# SERVICE INFORMATION

## STANDARD AND TRIUMPH VEHICLES

<b>No.</b>	SPORTS/4/E	ACCIDENTAL ENGAGEMENT OF REVERSE GEAR	<b>Date</b>	APRIL 1954
------------	------------	---------------------------------------	-------------	------------

1 ILLUSTRATION.

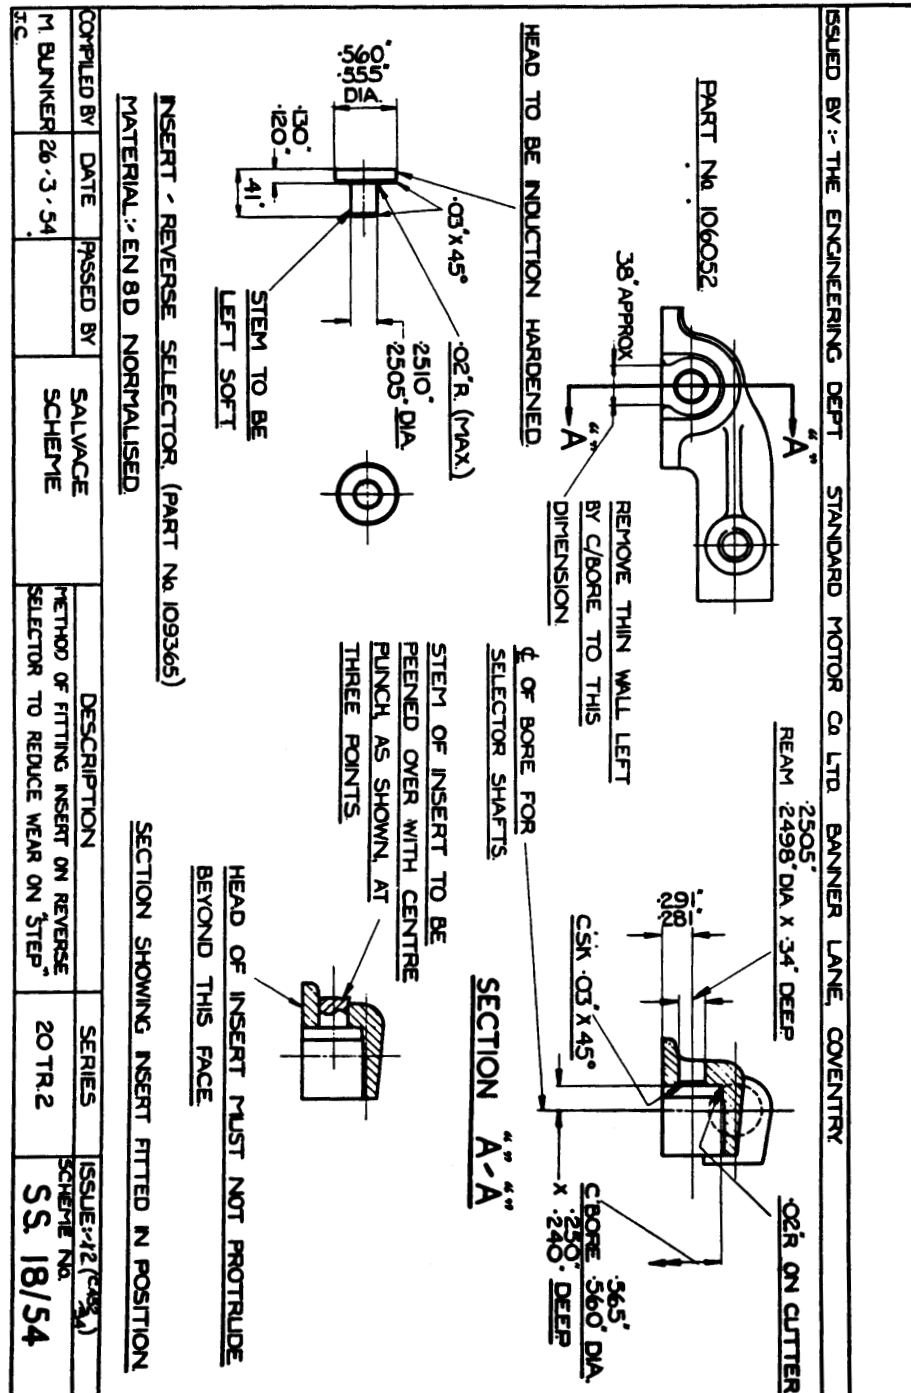
There have been cases, especially after rally tests involving rapid gear changing, of insufficient “baulking” against accidental engagement of “Reverse.”

Investigation has shown that this accidental engagement of “Reverse” is made possible owing to wear on the step in the phosphor bronze “Reverse” actuator.

The material for the “Reverse” actuator is specified for ultimate change to case-hardened steel, but until supplies become available it is intended to continue to use the phosphor bronze material with a hardened steel insert, Part No. 109365.

Where difficulty with accidental engagement of “Reverse” is experienced the hardened insert may be fitted to the selector, as shown in the illustration.
